**AGENDA**  
**Canmore Planning Commission**  
**Canmore Civic Centre – Council Chambers**  
**Wednesday, March 20, 2024**  
**2:00 p.m.**

## STAFF REPORT

<b>DATE:</b>	MARCH 20, 2024
<b>PROPOSED DEVELOPMENT:</b>	COMPREHENSIVELY DESIGNED MULTI-UNIT RESIDENTIAL DEVELOPMENT (18-UNIT STACKED TOWNHOUSE)
<b>APPLICATION NUMBER:</b>	PL20230389
<b>LEGAL DESCRIPTION:</b>	LOT 29, BLOCK 21, PLAN 231 690
<b>CIVIC ADDRESS:</b>	205 STEWART CREEK RISE
<b>CURRENT USE(S):</b>	VACANT LAND
<b>APPLICANT:</b>	CANMORE COMMUNITY HOUSING
<b>REFERENCED DOCUMENTS:</b>	LAND USE BYLAW 2018-22: <ul style="list-style-type: none"><li>• SECTION 3.21 R2A-SC DISTRICT</li><li>• SECTION 11 COMMUNITY ARCHITECTURAL &amp; URBAN DESIGN STANDARDS</li><li>• SECTION 12. DENSITY BONUS REGULATIONS</li></ul>

6 BUILDING 1 - WEST B  
1 : 100

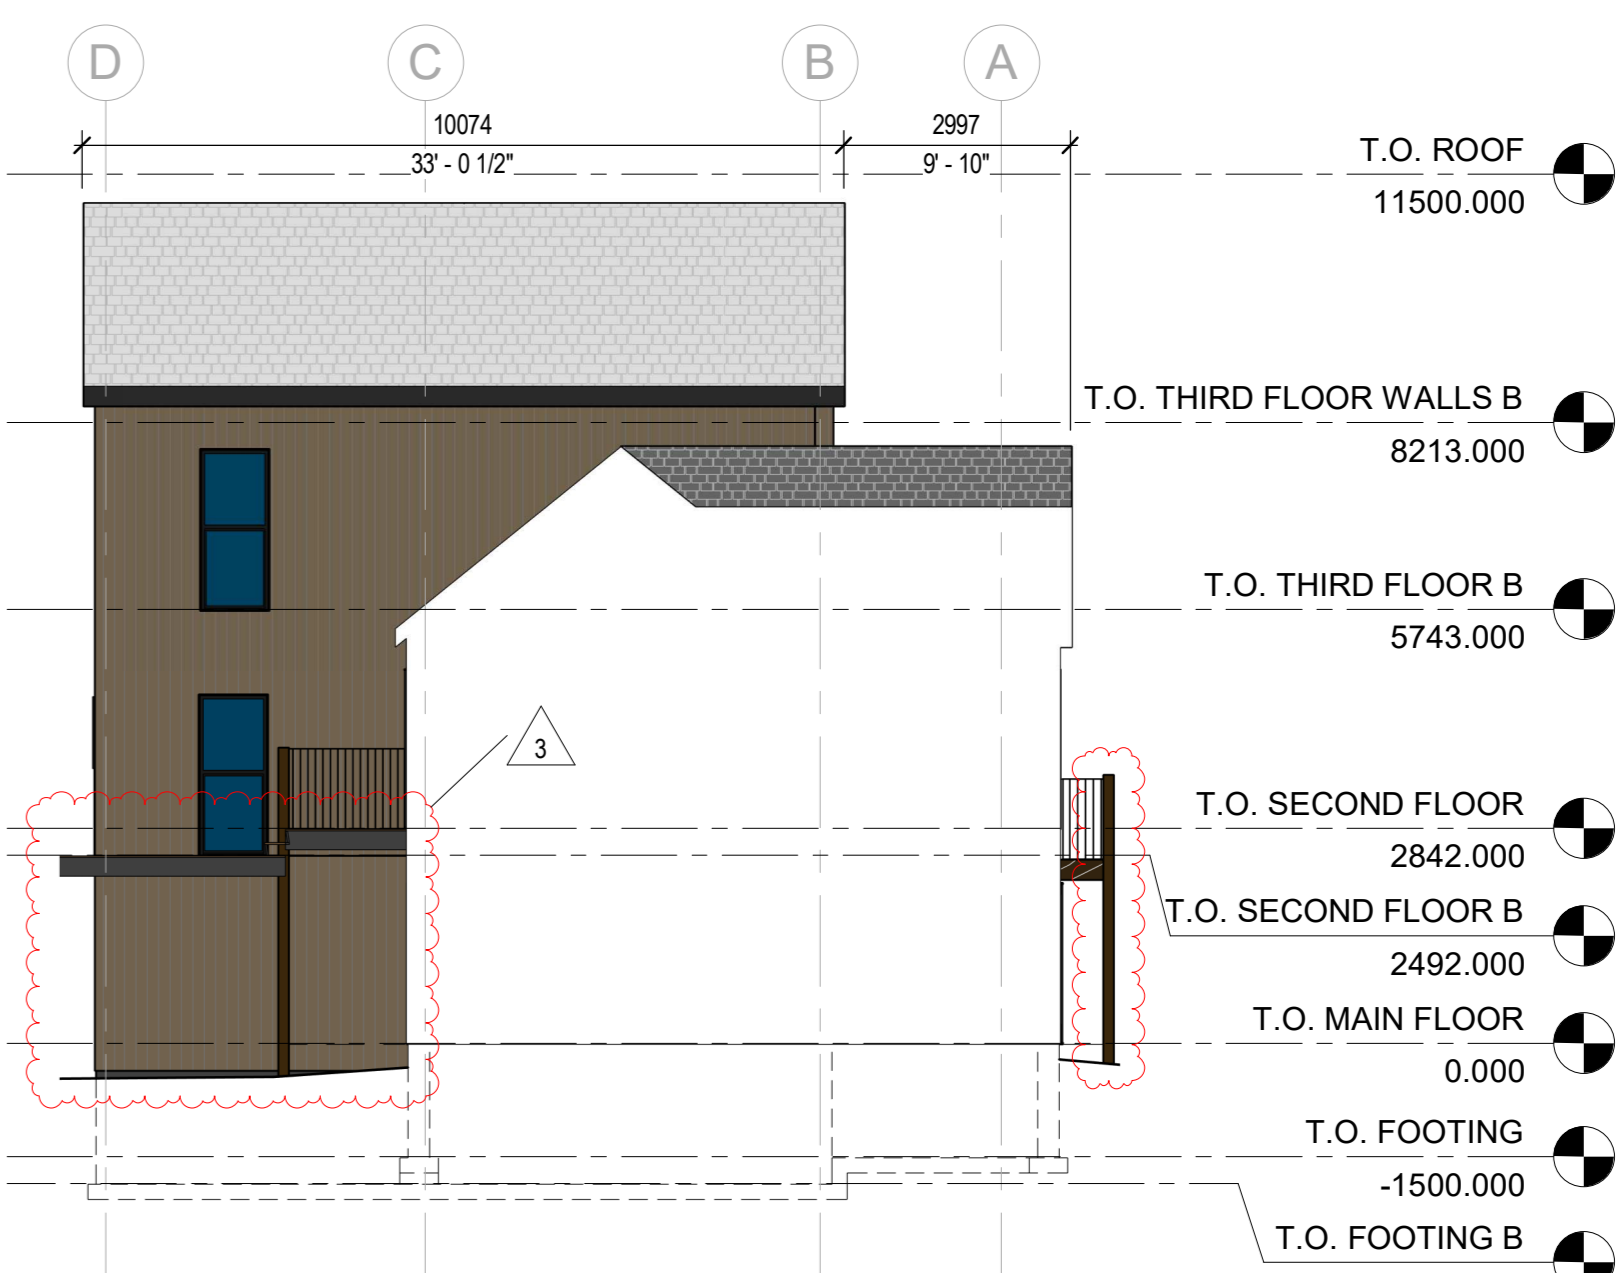
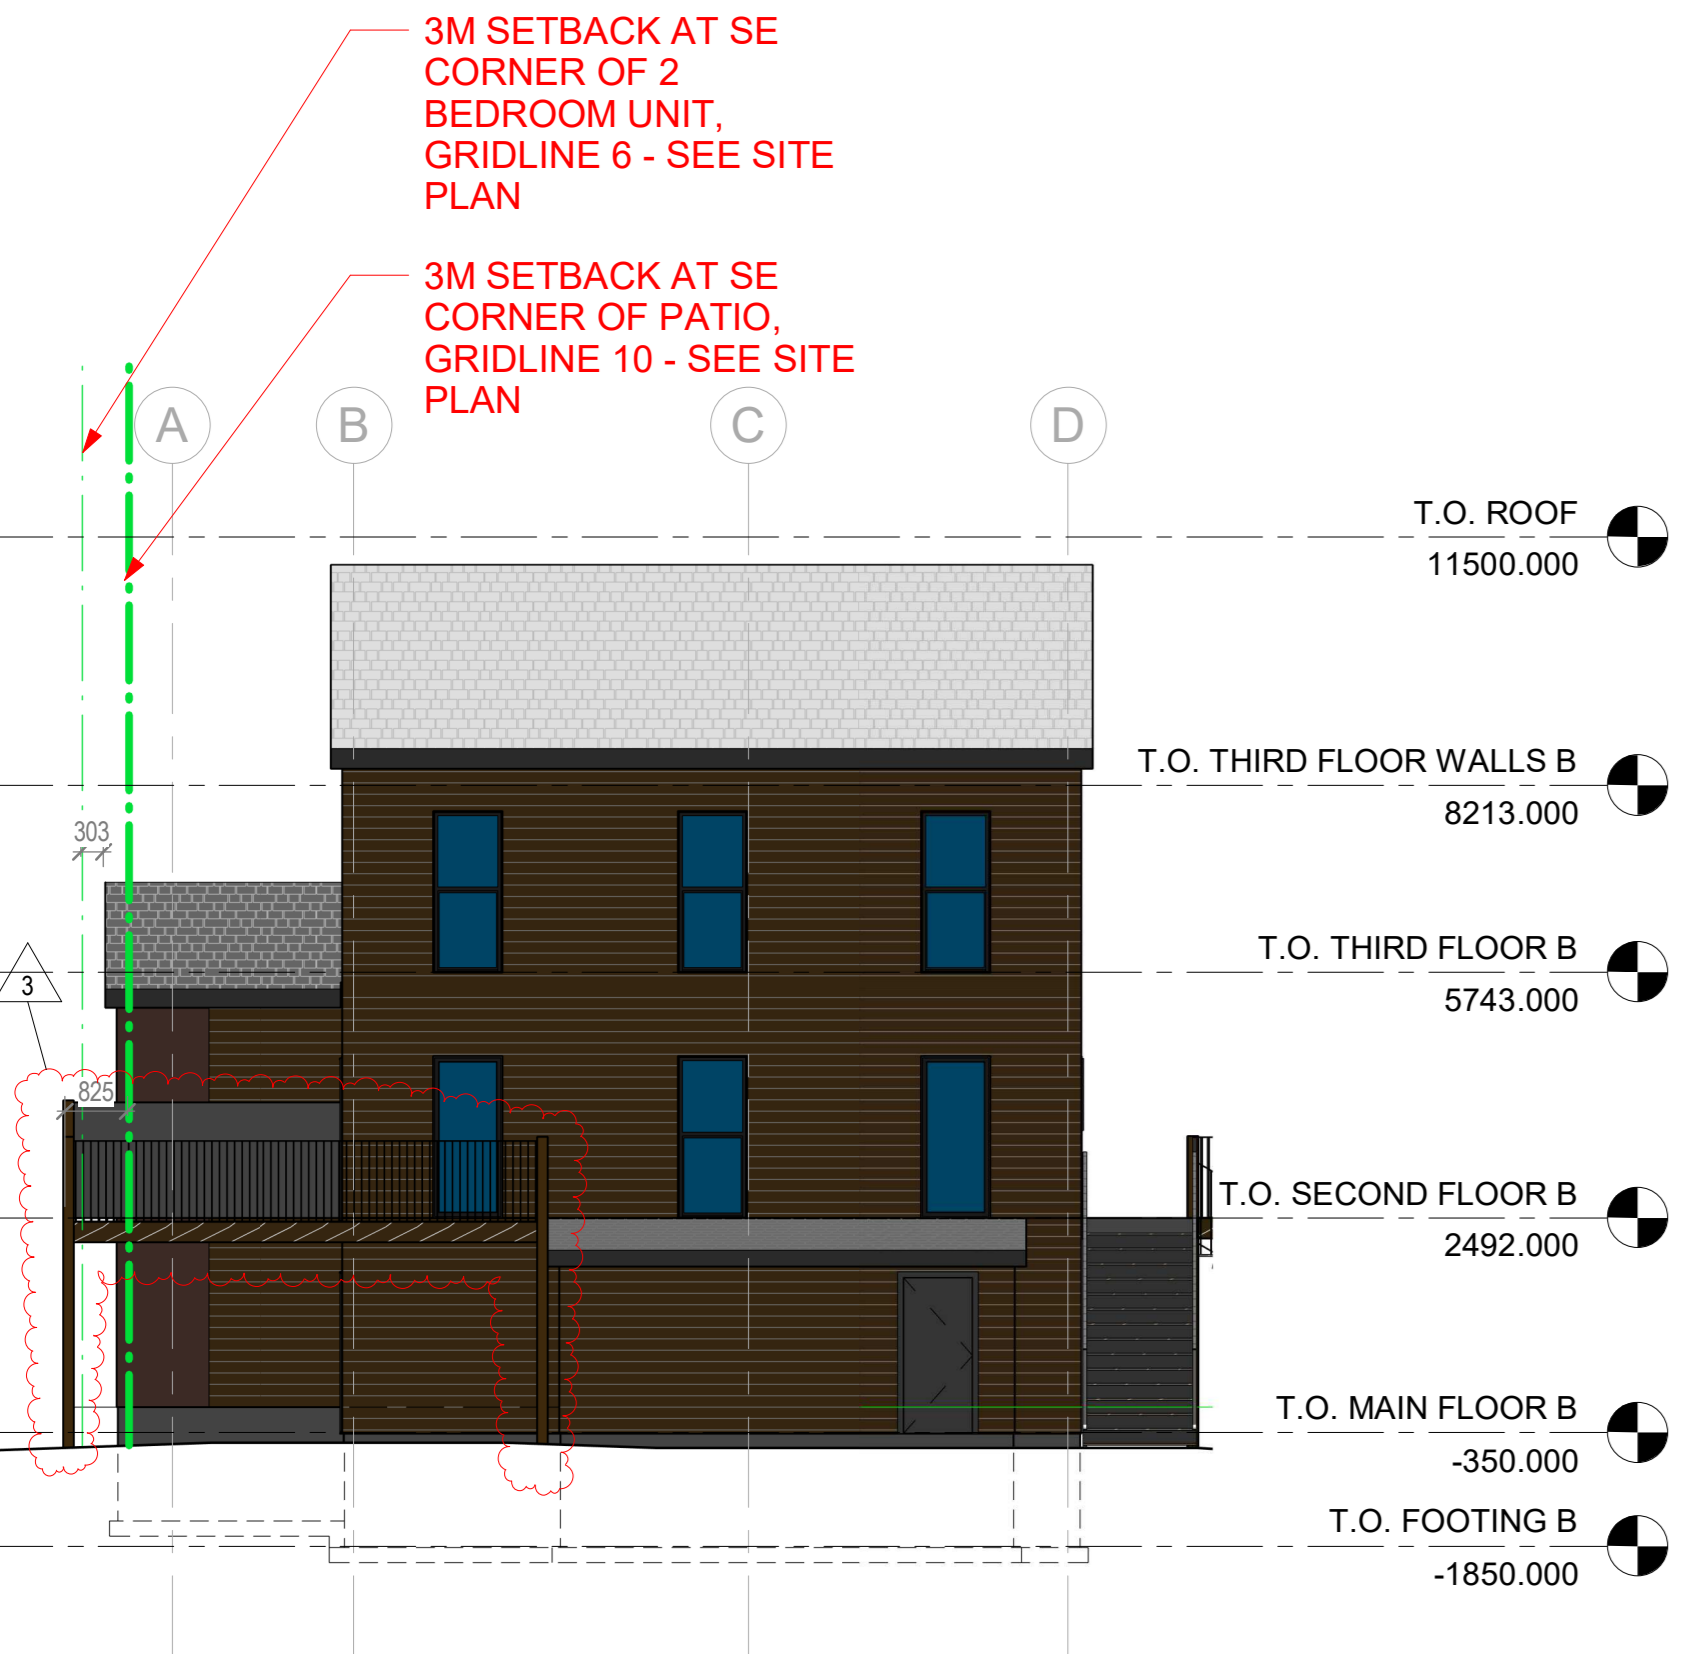
The proposed development is 11.67 m in height, requiring a 11.2% variance (see Figure 2 and 3).

With regards to impacts on adjacent developments, the development does not appear to unreasonably impact the access to views, privacy, or light of the adjacent properties. For example, the buildings step up as they move from their sides to their middle, which makes its impact on the east and west developments the same as, or even less than, a compliant building built to maximum height right to the setback (see Figures 2 and 3). Furthermore, there is 15 m of distance between the property line of this site and the adjacent site to the north. In addition, there is 26 m of separation between the rear property line of this site and the façade of the townhomes (excluding the garages) to the south. Finally, there are roof areas for both buildings that are substantially under height, which is to the advantage of the adjacent properties to the north and south.

Administration supports this variance given the community benefit of the project, and that the impacts of the variance are anticipated to be minor.
